From: "Magnetic Island Day Spa & Retreats" <magneticislandretreat@gmail.com>
Sent: Tue, 13 Oct 2026 12:50:56 +1000
To: "Development Assessment" <developmentassessment@townsville.qld.gov.au>
Subject: Final Information Request Response – MCU25/0039.01
Attachments: Sooning_Street_Site_Plan.pdf, Staging Plan - MCU25 0039.01.pdf

Staging Plan - MCU25 /0039.01 32 Sooning Street NELLY BAY

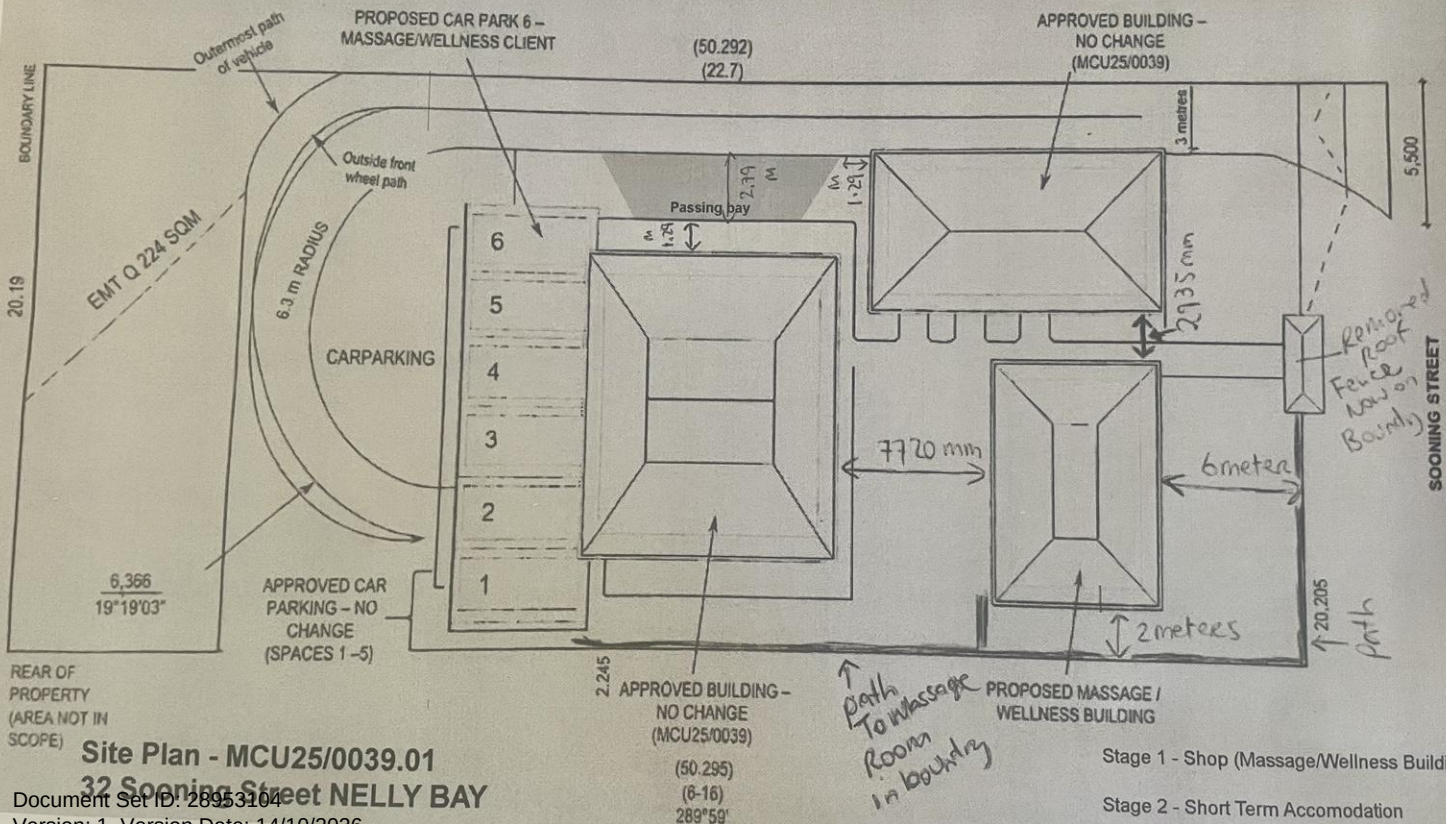
Please see the attached updated site plan, which includes the passing bay as requested, with all relevant dimensions clearly indicated.

The required passing bay width is **2.4 metres**, and we have provided **at least 2.79 metres** of clear width, exceeding this requirement.

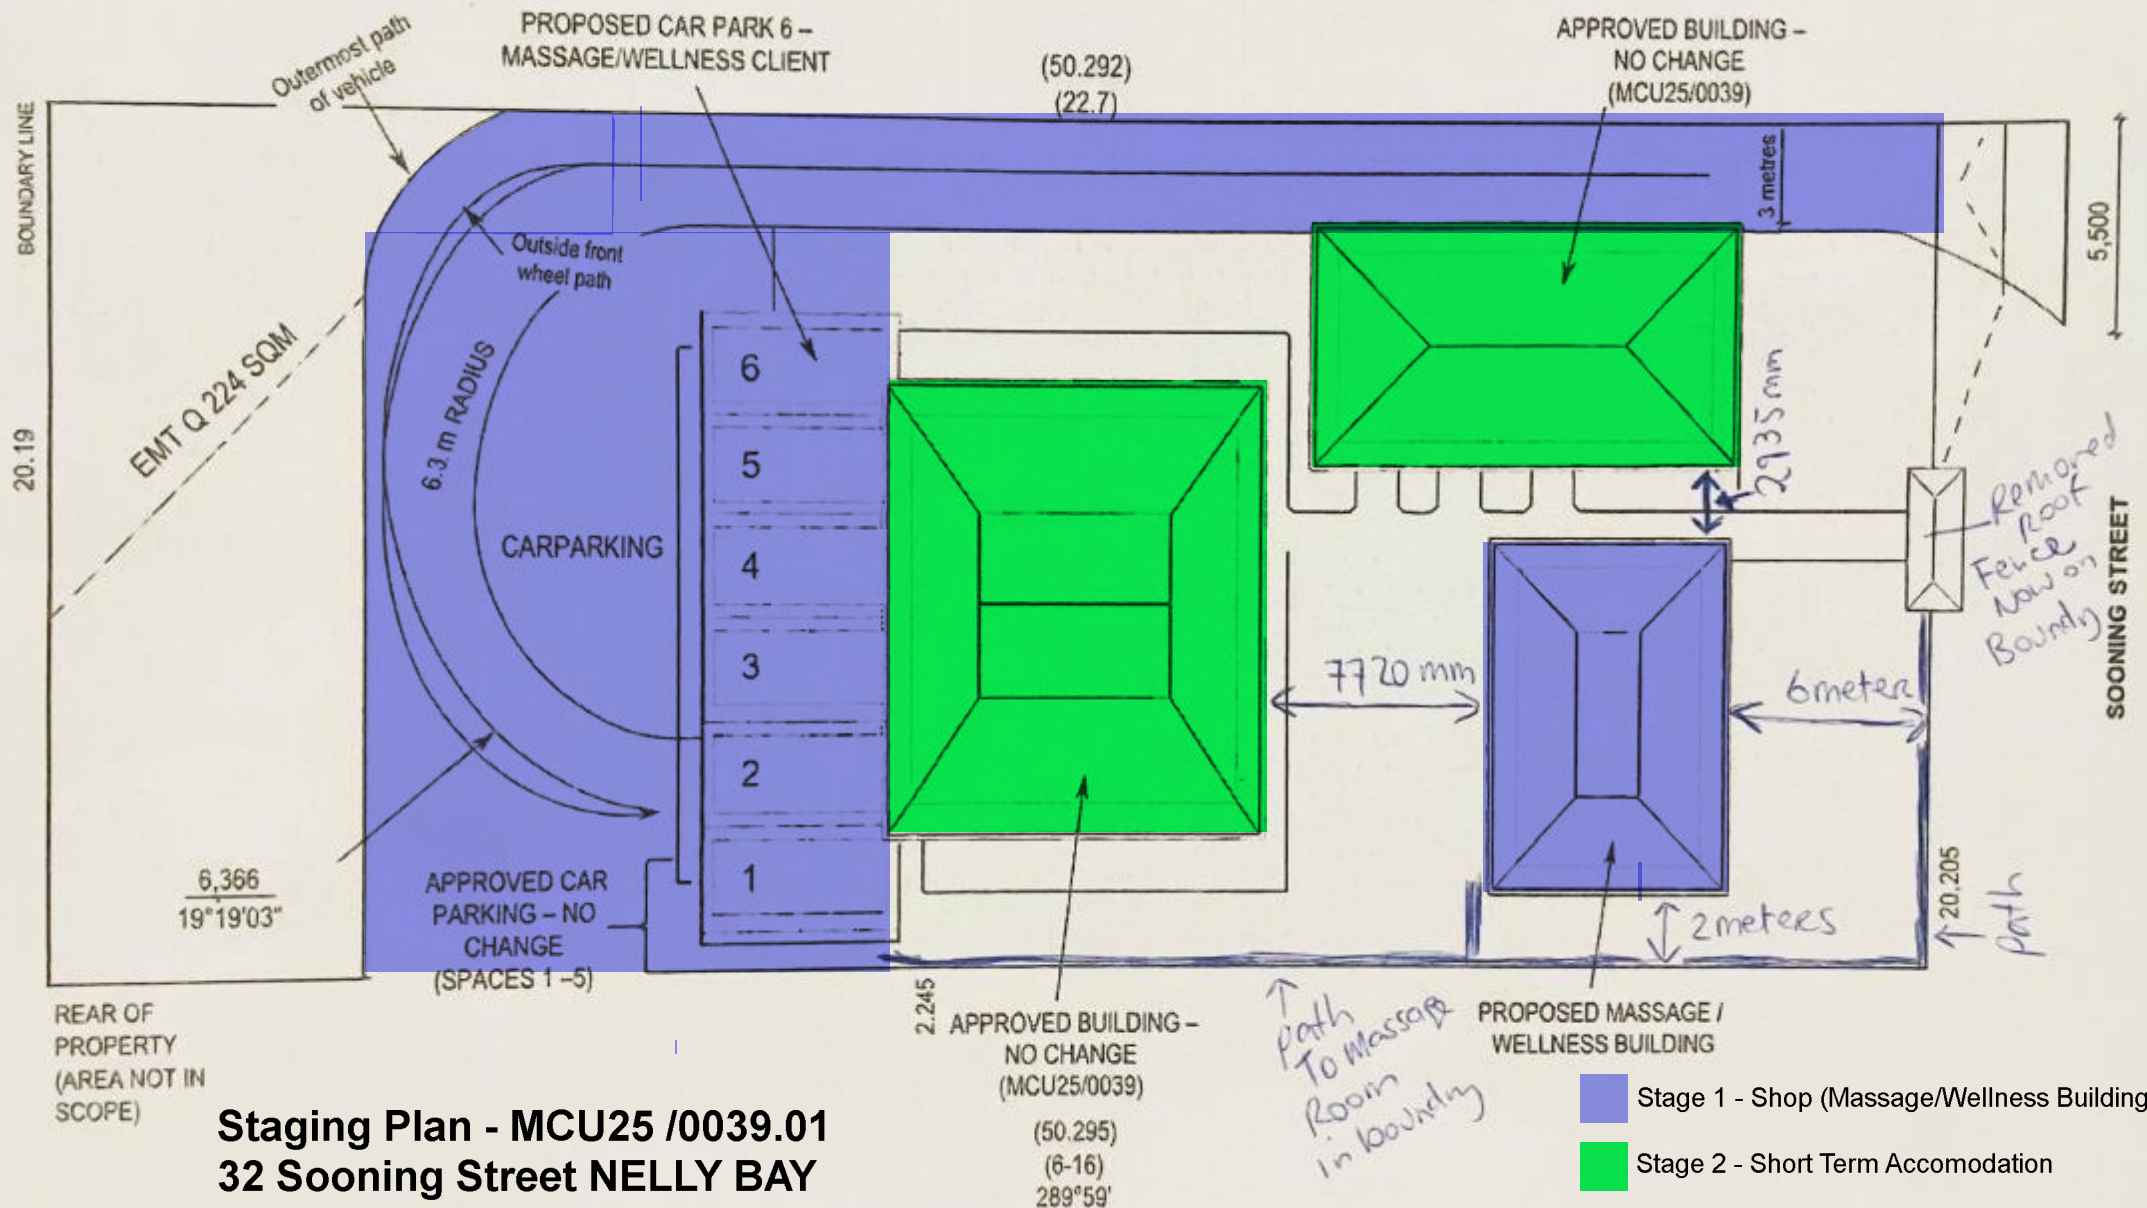
I have also gone a step further by including measurements from the outermost edges of each building, demonstrating at least **1.29 metres of clearance** on each side closest to the buildings.
